LAND USE SERVICES DEPARTMENT PLANNING COMMISSION STAFF REPORT

AGENDA ITEM #4

Project Description

Figure 1: Depiction of plot plan with permitted equipment operations used in Table 1. Conveyors outlined in red.

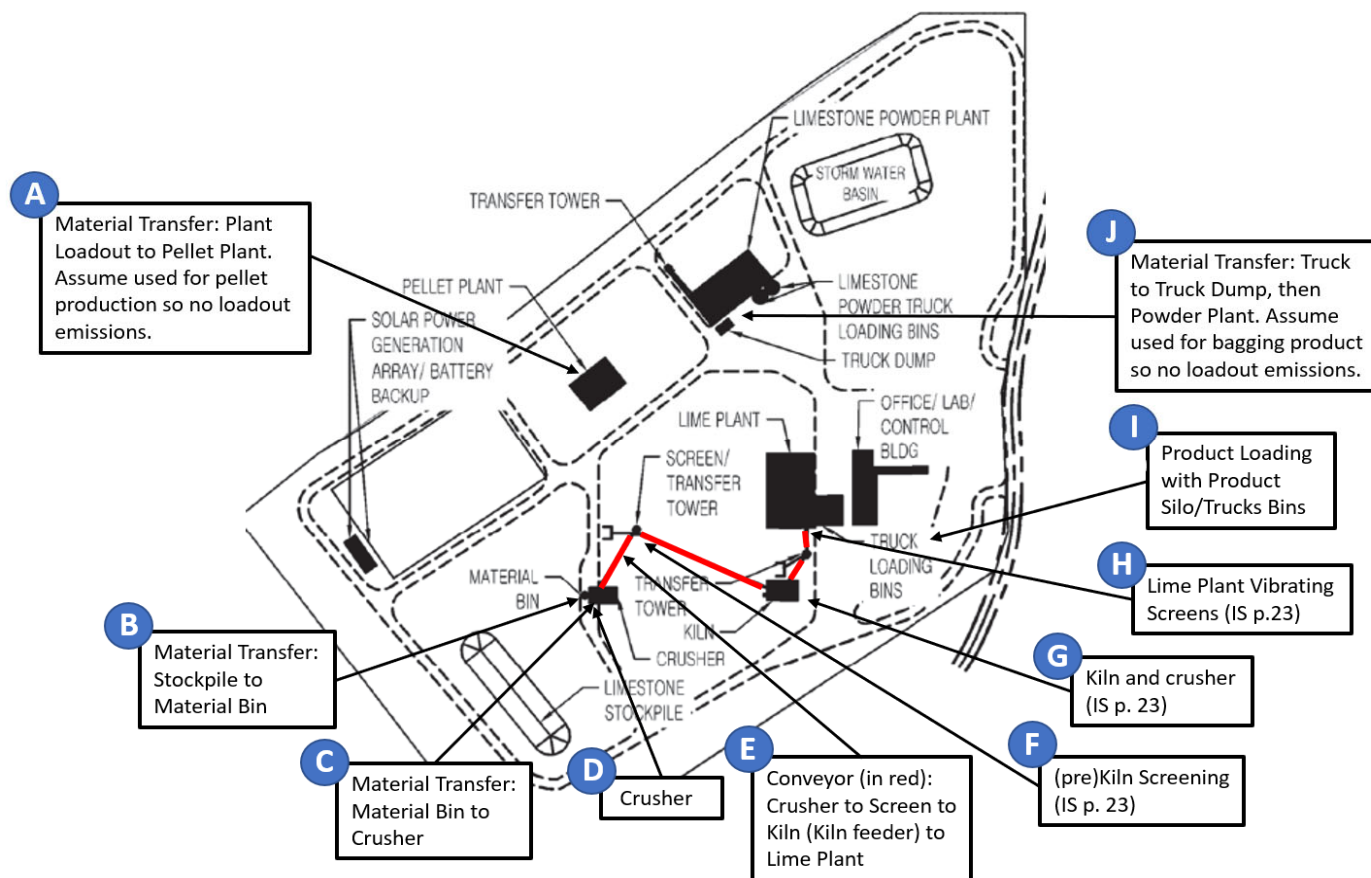
6. Case B: PVL Emissions with Additions represents emissions based on Lhoist's equipment list.
7. Reference to Figure 1, which provides a schematic of PVL plant operations based on the plot plan and description in the Initial Study.

Figure 1: Depiction of plot plan with permitted equipment operations used in Table 1. Conveyors outlined in red.

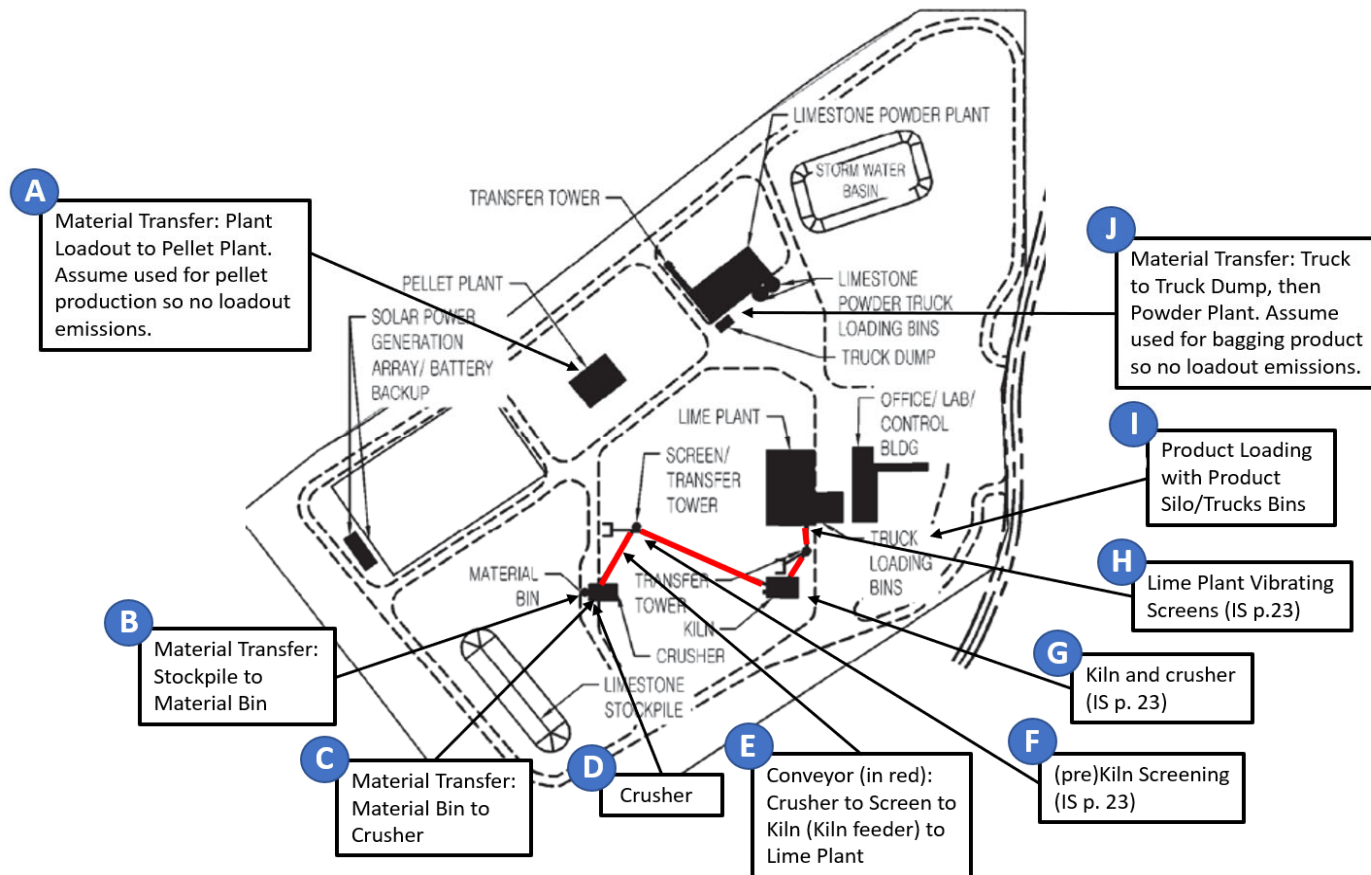
6. Case B: PVL Emissions with Additions represents emissions based on Lhoist's equipment list.
7. Reference to Figure 1, which provides a schematic of PVL plant operations based on the plot plan and description in the Initial Study.

3-59 Attached to these comments is a revised Plot Plan provided for clarity (Attachment 6), and also responds to certain assumptive errors made by the commenter regarding the Project operations. The Plot Plan and Site Plan Zones provided in the IS/MND as Figures 4 and 5 respectively identified a crusher as part of the PVL Lime Plant; these figures have been updated and the project description on p. 4 and the operational process description on p. 23 of the IS/MND are hereby revised to remove the references to reflect that a rock crusher is not required and will not be developed as part of this Project. As previously stated, the lime that will be delivered from Panamint Valley to the PVL Lime Plant will not require crushing on the Project site. The plot plan provided in this comment also incorrectly identifies other details, including, for example: a pellet plant (see box "A"), which is not a part of the Project; and, material transfer from the stockpile to the material bin (see box "B"), which will not occur, as the stockpiles on the Project site will feed directly to a main feed conveyor, moving the feed directly to small and large rock storage silos, as reflected in the Process Flow Diagrams provided in Attachment 6.
